# Technical Note

**Project:** Cambridge North Development

**Subject:** Flood Risk Assessment Addendum

<b>Client:</b>	Brookgate Land Limited	<b>Version:</b>	D
<b>Project No:</b>	05425	<b>Author:</b>	JG
<b>Date:</b>	13/10/2022	<b>Approved:</b>	MC

**DRAWING TITLE**  
 Proposed Drainage Strategy - Basin

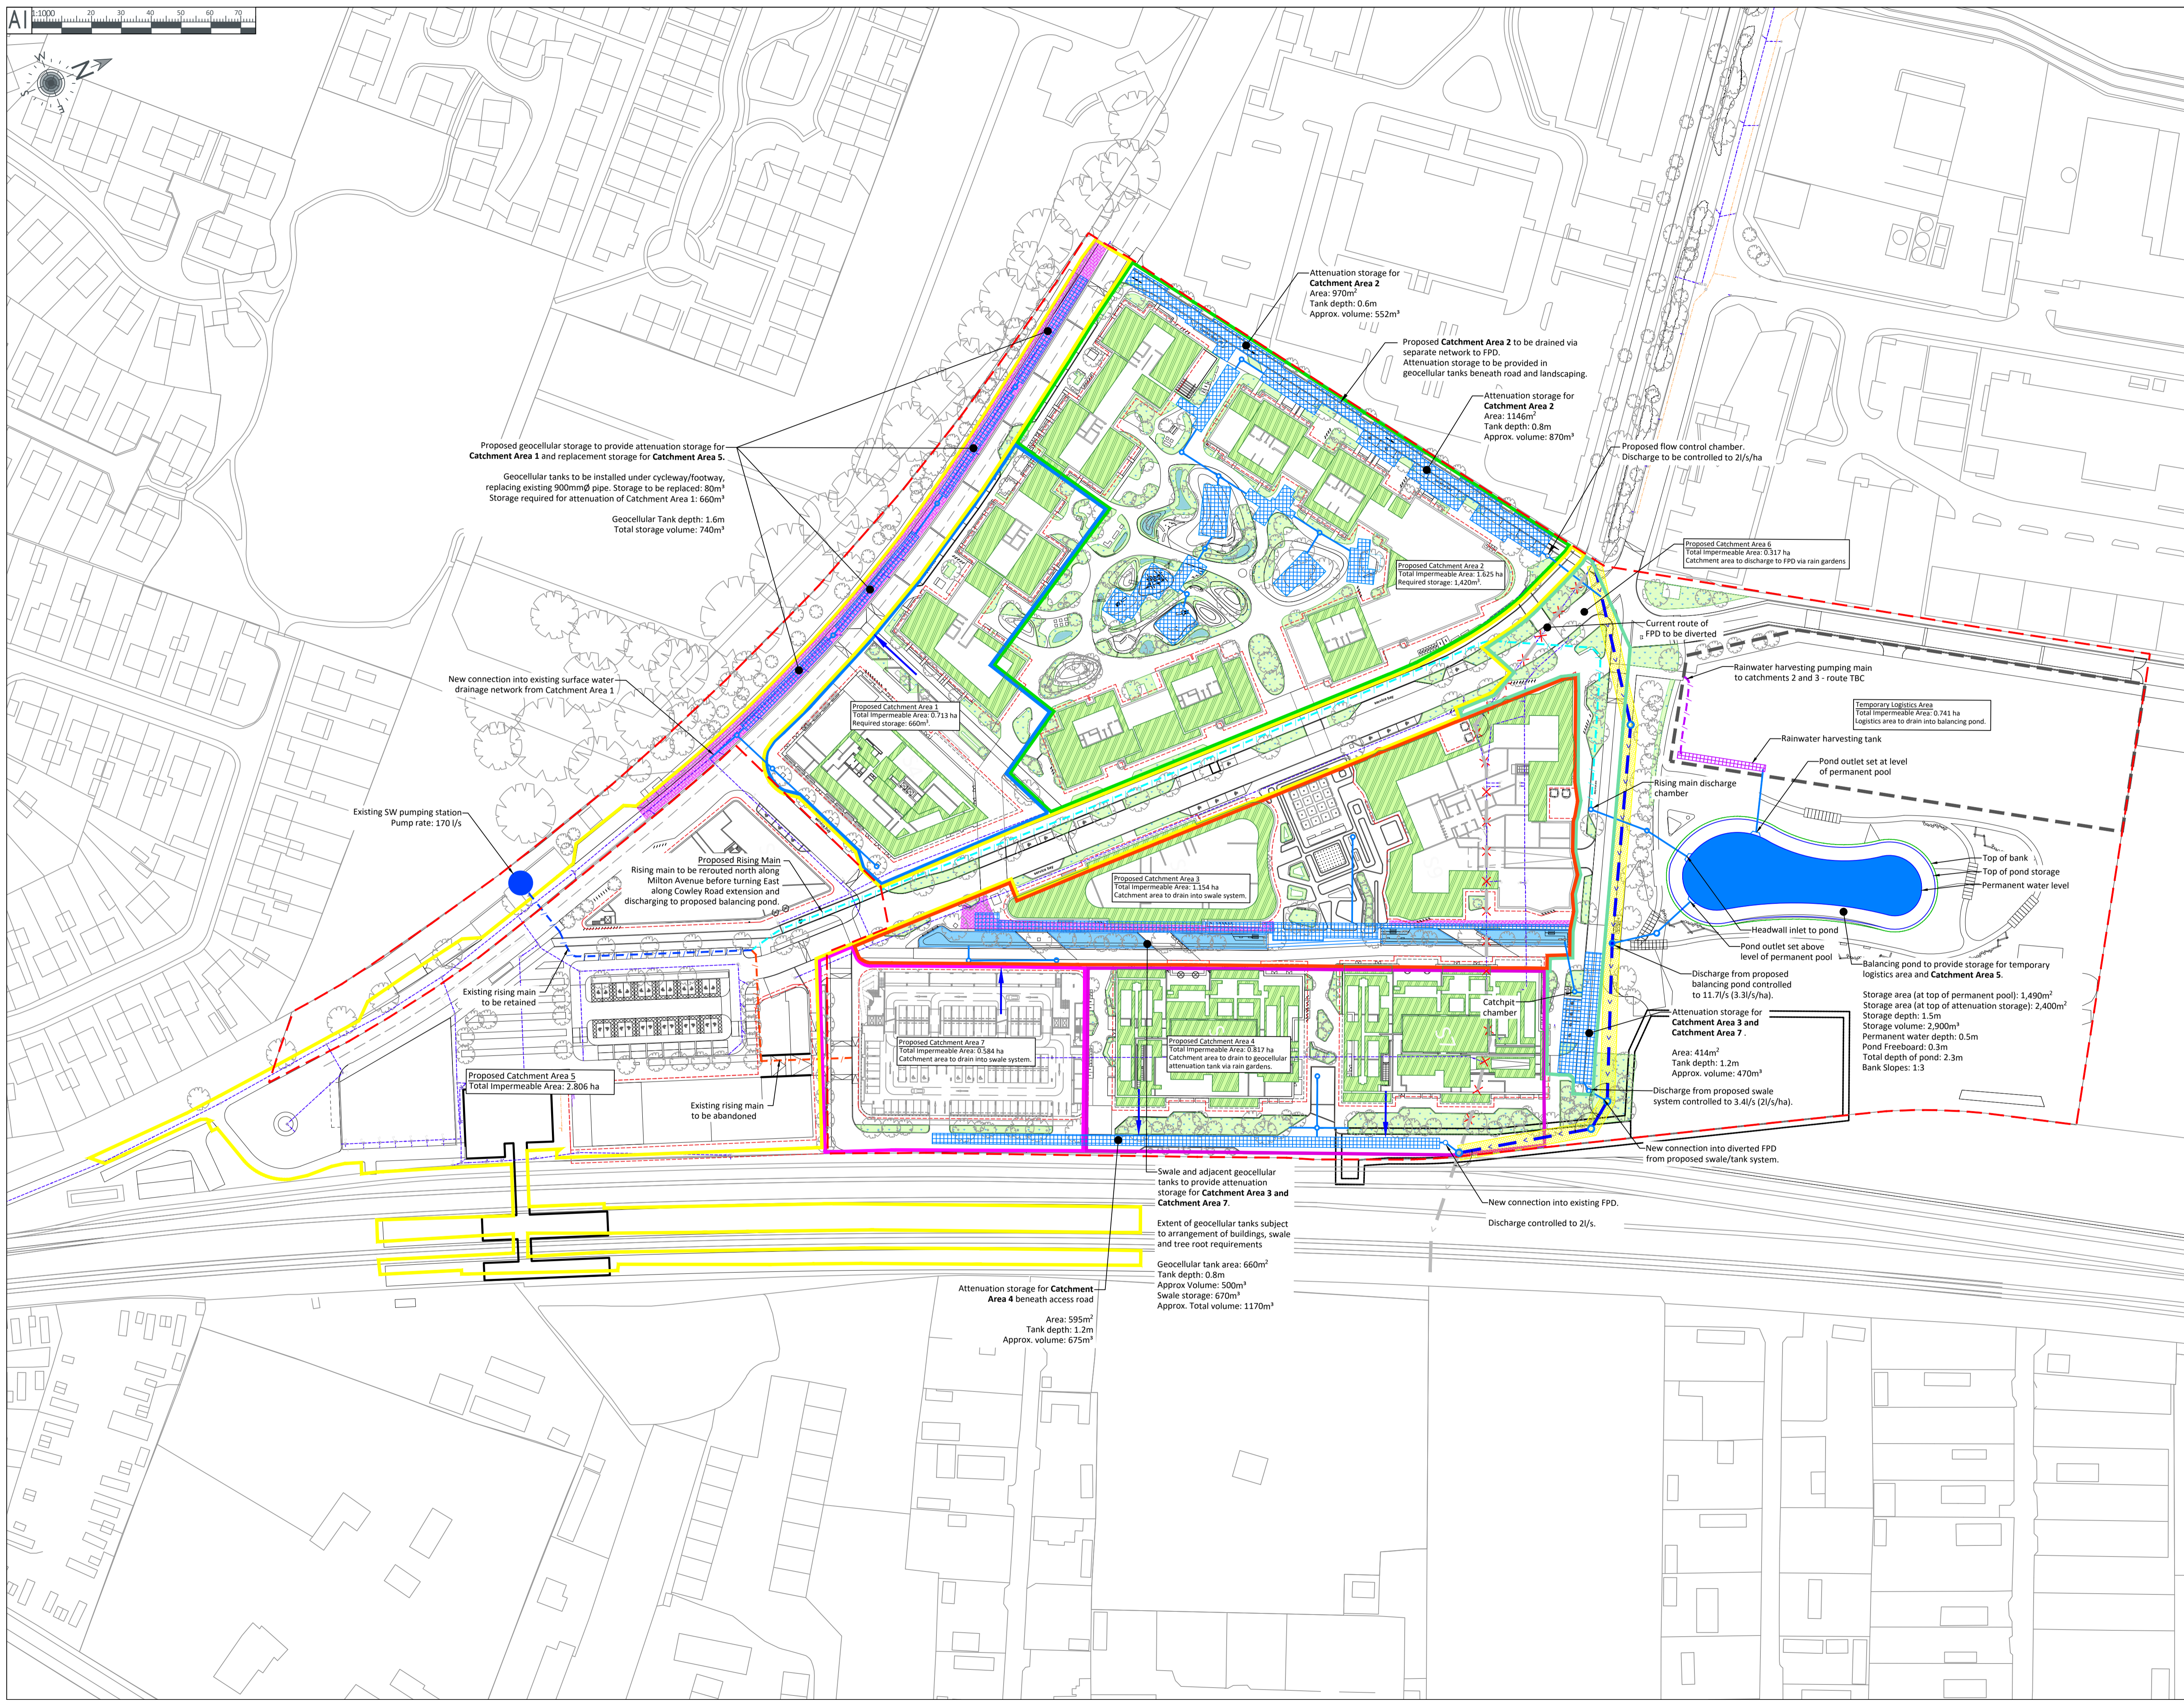
3.1.1 The Cambridge City Council consultation response states that the proposed diversion of the First Public Drain Overflow introduces a number of 90 degree bends, noting that this will likely impact upon the culvert capacity and risk of blockages.

5.1.1 The Cambridge City Council consultation response notes that green roofs and permeable paving should be more widely used throughout the development. The Drainage Strategy drawing has been updated to show additional green roofs, rain gardens and areas of permeable paving/porous asphalt throughout the site, and further amendments have been made to the presentation of this information on the drawing in order to improve clarity.

6.1.2 This reduces the space available for the proposed swale that was previously shown running parallel to the footway/cycleway. In the previous strategy the swale provided around 44% of the attenuation storage required for Catchment 1, with the remaining 56% provided in underground storage tanks beneath the busway.

3.1.2 The route of the diversion has been revised to create an alignment with angles of change in direction similar to, and where possible less acute than, those on the existing culvert (approx. 130°). By adjusting the alignment of the diversion and introducing an additional chamber along

the route, the angles have been increased to approx. 120°, 130°, and 150°. The revised route is shown on the updated Drainage Strategy (Appendix D).

- 6.1.3 The widening leaves only a limited area available between the proposed cycleway/footway and the wooded area to the west. To minimise the impact on tree roots in this area, and to retain as much of the existing Open Mosaic Habitat as possible, it is proposed that a swale will not be provided in this area. Attenuation storage for Catchment 1 will instead be provided entirely in underground tanks. The Drainage Strategy drawing has been updated to reflect this change (included at Appendix D).

REV	DATE	REVISION NOTE	BY
P7	11/10/22	FPD diversion amended. Green roofs, rain gardens and permeable paving updated.	JG
P6	15/09/22	Catchment 1 attenuation storage updated.	JG
P5	01/09/22	Updated according to L1FA comments. Indicative rainwater harvesting system shown.	JG
P4	27/05/22	Updated to suit revised site layout.	JG
P3	30/03/22	Attenuation basin, residential attenuation tanks and rain gardens updated.	DS
P2	15/02/22	Updated to suit revised masterplan.	JG
P1	28/01/22	Drainage layout amended following masterplan update, attenuation basin revised, FPD easement added, Chesterton Square attenuation tank revised and green / brown roof area added.	DS
P0	07/12/21	First Issue	DS
